Conceptual Review Agenda

Time	Project Name	Applicant Info	Project Description	
10:15	NE Mulberry and I-25 – Annexation and ODP CDR220046	Ken Merritt 970-305-6754 kmerritt@jrengineering.com	This is a request for annexation and development of an Overall Development Plan (ODP) for commercial, retail, and industrial uses at the NE corner of the I-25 and Mulberry Ave interchange. (Parcel # 8710000029). The Subject property is approximately 46.9 acres in size and is contiguous to the City of Fort Collins. The proposal is to Annex the property to the City and Zone the western portion of the property, being approximately 10 acres, CG-General Commercial with the remaining 32.25 acres to be Zoned CS-Service Commercial. Additionally, the Annexation and Zoning submittal will also include an Overall Development Plan (ODP). Access would be taken from the NE Frontage Rd. The site is located directly north and east of NE Frontage Rd. The site is outside of city limits but falls within the City's Growth Management Area. The annexation proposal will be subject to City Council Review.	Planner: Kai Kleer Engineer: John Gerwel DRC: Todd Sullivan

Subject: I-25 & Mulberry – Conceptual Review (Annexatio

OVERALL DEVELOPMENTAL PLAN

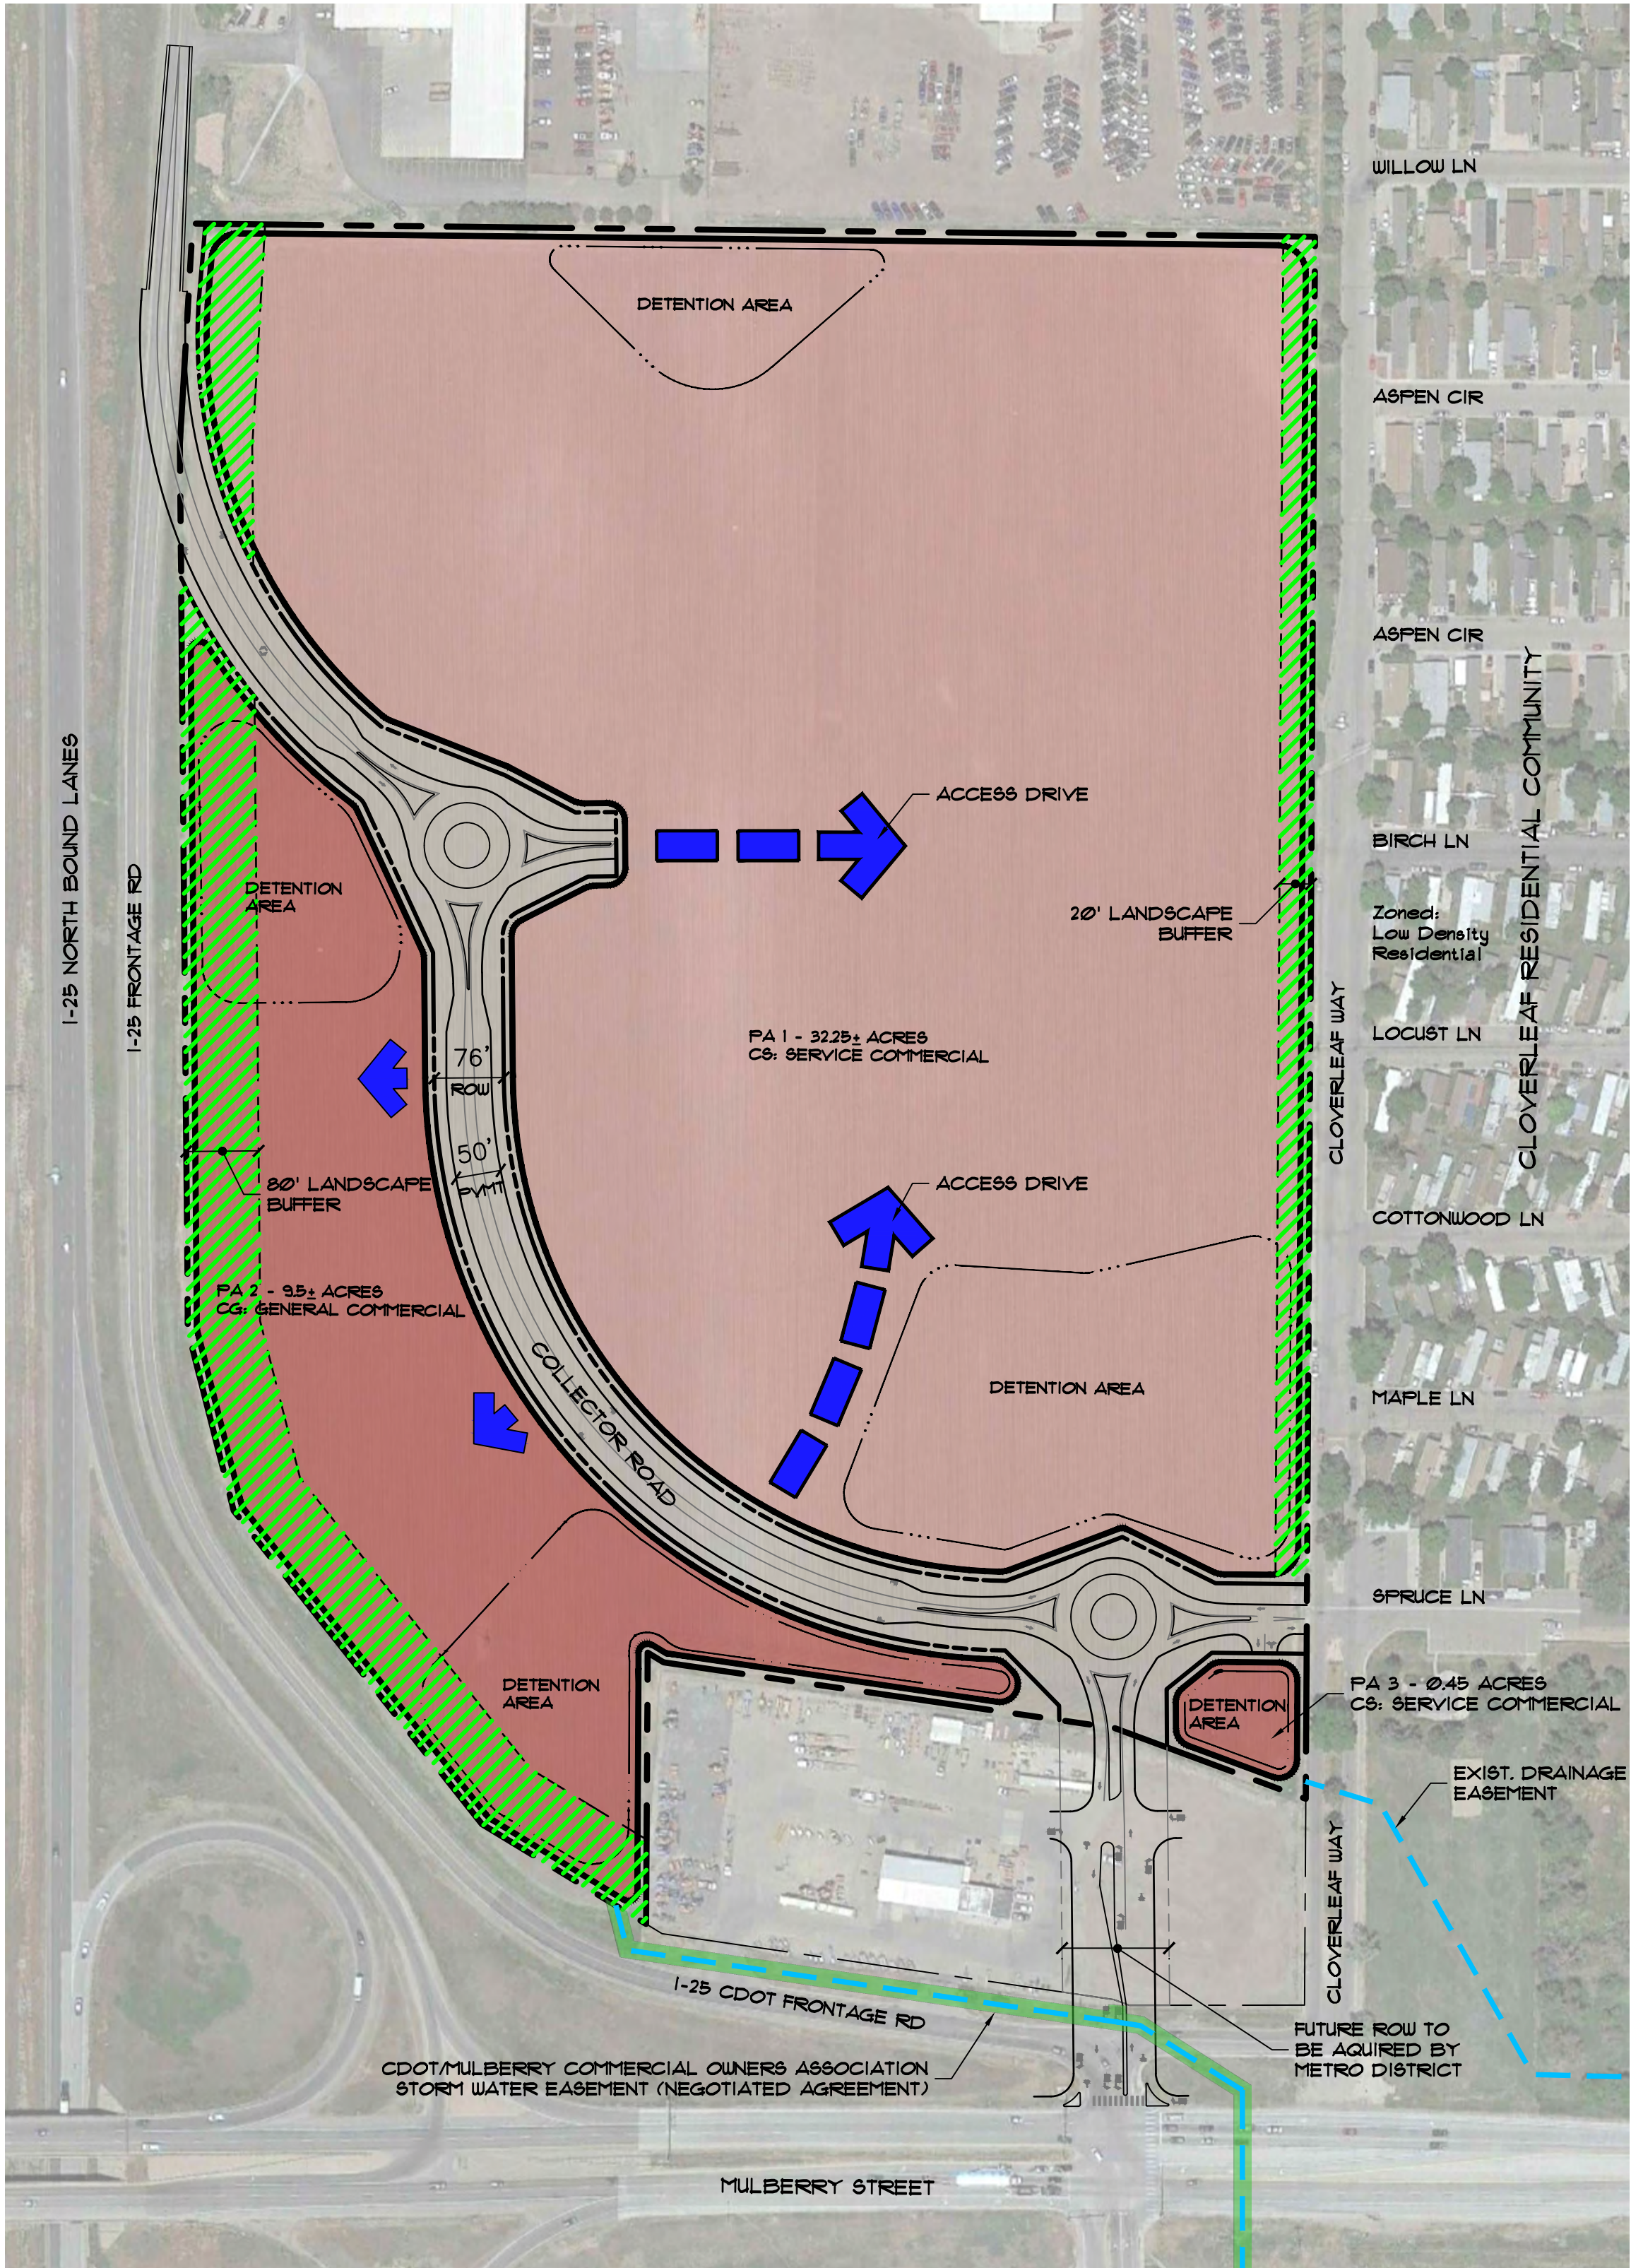
- The newly aligned Frontage Road includes two proposed roundabouts, and a curvilinear configuration that deviates from the City of Fort Collins Transportation Master Plan. This proposed alignment has been reviewed with City staff in the past and we believe all are in agreement that this configuration is the best solution, but what if anything will need to be done to deviate as shown in the Overall Development Plan Exhibit? Are the roundabouts, which help to reconnect to the Frontage Road to the north in accordance with the minimum horizontal radius allowed by LCUASS, as an acceptable solution to the existing Frontage Road at the northwest corner of the site?

- Considering the regional detention ponds shown at the east side of the site, will the City allow retaining walls within these ponds?
- Concerning the storm pipes proposed to cross under Mulberry to the southern channel that leads to Boxelder Creek, what construction methods will the City allow our contractor to utilize?

- Our understanding is that there will be an 80' landscape buffer required along the western boundary of the site. The current Frontage Road will be decommissioned as a Frontage Road, and thus will buffer the site from the travelled highway even more. The owner would like to see this buffer reduced or to have the buffer's western edge be slid toward/over the current Frontage Road location in an effort to increase the developable General Commercial area to a more acceptable width that can support the businesses that are planned to be located along the interchange at I-25.
